Joseph M. Farley Nuclear Plant – Unit 1
Vogtle Electric Generating Plant – Units 1 & 2
Response to NRC Request for Additional Information Regarding
Inservice Inspection Alternatives for Reactor Pressure Vessel Examinations

SNC Response to NRC RAI Related to Request ISI-GEN-ALT-06-02

REQUEST FOR ADDITIONAL INFORMATION
BY THE OFFICE OF NUCLEAR REACTOR REGULATION
RELATED TO REQUEST ISI-GEN-ALT-06-02
JOSEPH M. FARLEY NUCLEAR PLANT, UNIT 1
VOGTLE ELECTRIC GENERATING PLANT, UNITS 1 AND 2
SOUTHERN NUCLEAR OPERATING COMPANY
DOCKET NOS. 50-348, 50-424, AND 50-425

FIGURE 1
 (Illustrative Purposes Only - not to scale)

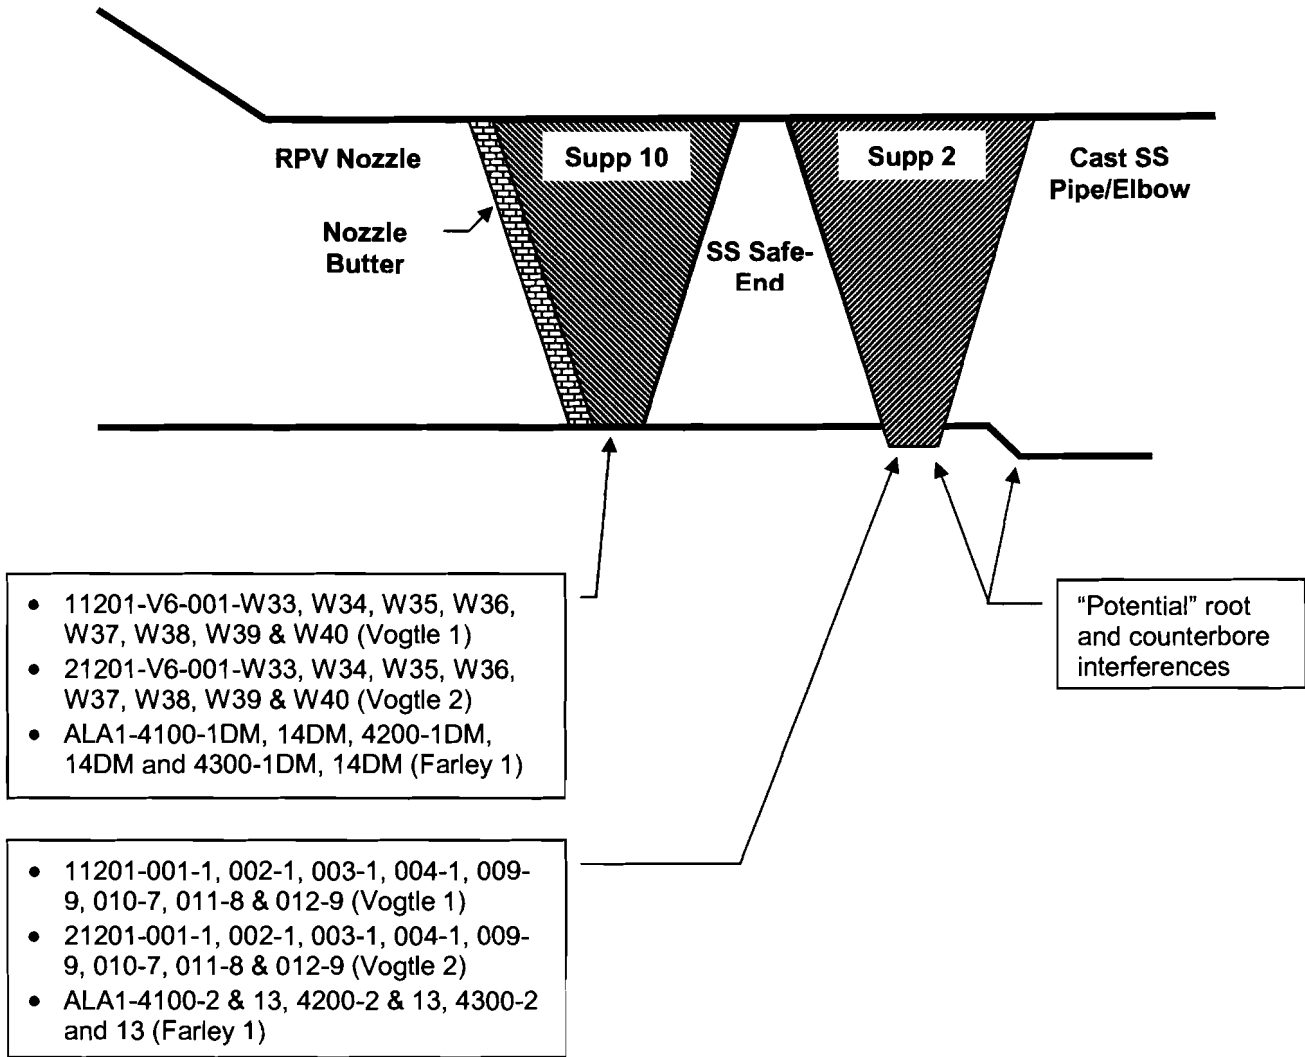
Item 3

Explain why the ASME Code RMS value is not achievable for the selected vendor.

The difficulty of achieving the required 0.125-inch RMS error factor results from ID geometry interferences (e.g., root, counterbore). To accurately size thru-wall indications, the transducers ability to scan over the flaw must not be impeded by these interferences. The qualification mockups for both Supplements 2 and 10 were fabricated from field supplied data, representing the expected worse case scenarios. In most cases, the austenitic joint (Supplement 2) is field welded with root and counterbore restrictions occurring. For most 3 and 4 loop Westinghouse designs, the dissimilar metal (DSM) joint (Supplement 10) has been shop machined, resulting in little or no geometric interferences. Both Farley and Vogtle Supplement 10 configurations are expected to be unimpeded. Therefore, it is expected that the proposed alternative 0.189-inch RMS error factor would be a conservative alternative compared to the qualification specimens. Part of the examination process for remote mechanized inspections is the gathering of profile data. This information is used for coverage determinations. The data is also being collected to ensure qualification mockups represent the full alignment of field conditions within the industry. Surface scan access and/or cast material difficulties restrict the examinations for the Farley and Vogtle configurations from the outside diameter (OD). A figure is provided for illustrative purposes.
